CITY OF FORT LAUDERDALE

CASE COMMENT REPORT

CASE NO. UDP-S25053

CASE	UDP-S25053
PROJECT NAME	11 North Andrews
APPLICATION TYPE	Site Plan Level II (RAC) Review
APPROVAL LEVEL	City Commission
REQUEST	Amend Previously Approved Mixed-Use Development consisting of 378 Residential Flex Units and 5,605 SF Commercial Use with Design Deviations
APPLICANT	Bachow Fam OZ Fund, LLC
AGENT	Robert Lochrie / Lochrie and Chakas
PROPERTY ADDRESS	11 N. Andrews Avenue
ABBREVIATED LEGAL DESCRIPTION	Ft Lauderdale B-40 D Lots 14-17 Blk 13
ZONING DISTRICT	Regional Activity Center – City Center (RAC-CC) District
LAND USE	Downtown Regional Activity Center
COMMISSION DISTRICT	2 – Steven Glassman
NEIGHBORHOOD ASSOCIATION	Flagler Village Civic Association
SUBMITTED	November 20, 2025
COMPLETENESS ISSUED	December 19, 2025
STATE STATUTE 166.033 EXPIRATION	June 17, 2026 (180 Days)
CASE PLANNER	Tyler Laforme, AICP, Urban Planner III

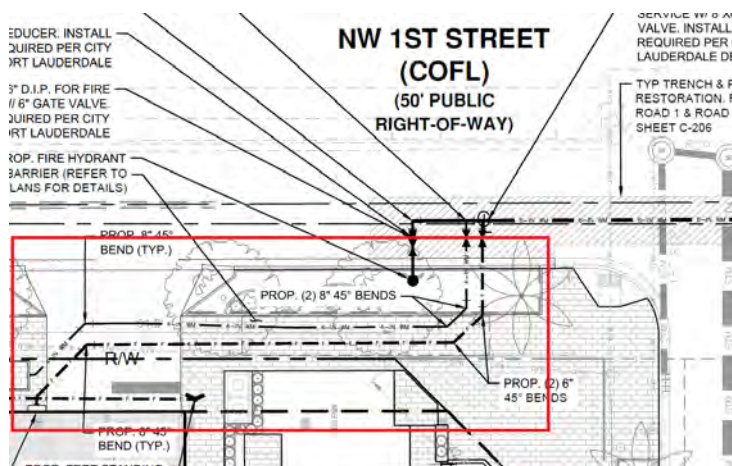
- a. The 15-ft measurement for the meter easement shown on plan sheet C-300 needs to be revised to measure from the meter assembly itself to the concrete slab as shown below:

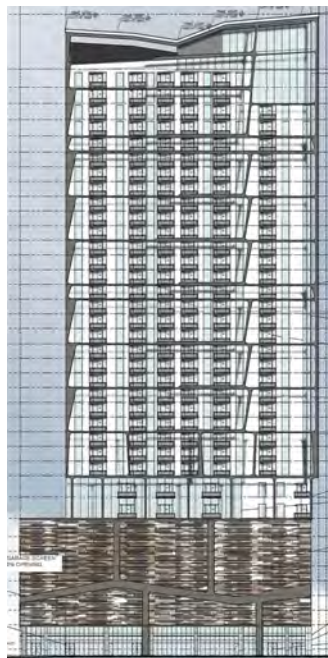
- a. B-5) Provide detailed justification for the increase in floorplate size from the maximum allowable 12,500 square feet to 19,332 square feet (a 54.6% increase). At this time the applicant has not demonstrated that the increase meets the design intent.
- b. B-10) Provide a significant and dramatic design for the building corner at Broward Boulevard and Andrews Avenue to emphasize the architecture, entrance, and character of the building. Some options include: a triple floor to ceiling height at ground level at the corner to provide a respite for pedestrians while giving the building a stronger sense of identity, enhance the main lobby entrance to the building with different material use, variation in ceiling height,, emphasize an architectural element(s) that can align vertically to the tower top.

Proposed Design

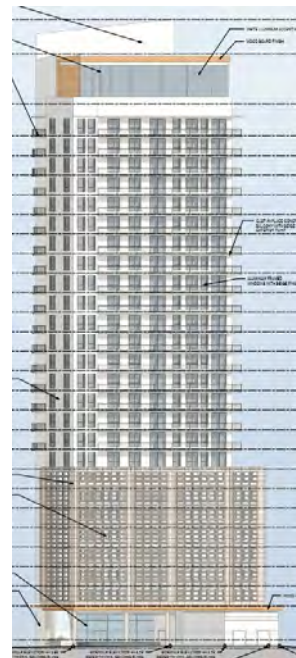
b. Q-2) The project should account for the larger massing through a creative and thoughtful tower top design. Using large horizontal/vertical, solid flat planes perpetuates the massiveness of the overall building. See current approval tower top design for clarity on how to remedy some of the massiveness of the building through thinner, lighter elements with multiple material types.

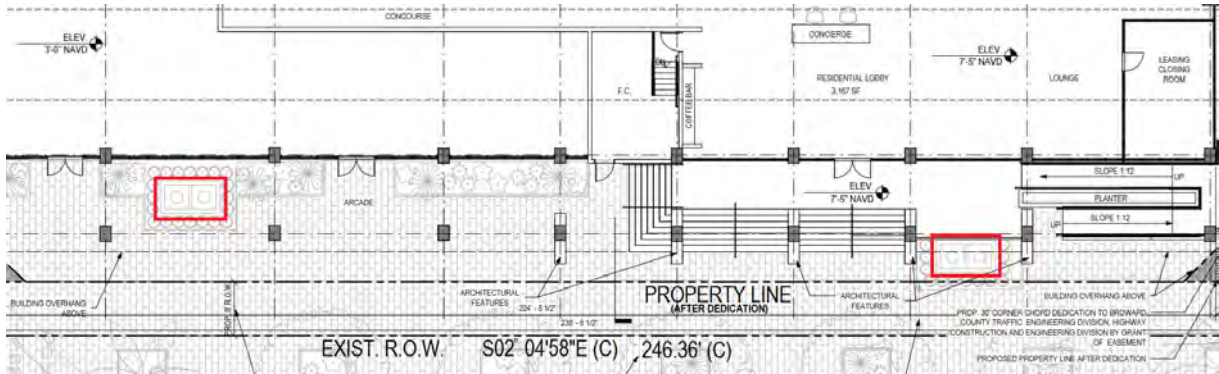
- d. Q-5) Proposed parking screening is not exceptional as required by the master plan. Additional design treatments are needed that can provide variety, articulate, and adequately screen. Examine design options that are more visually engaging given the location.
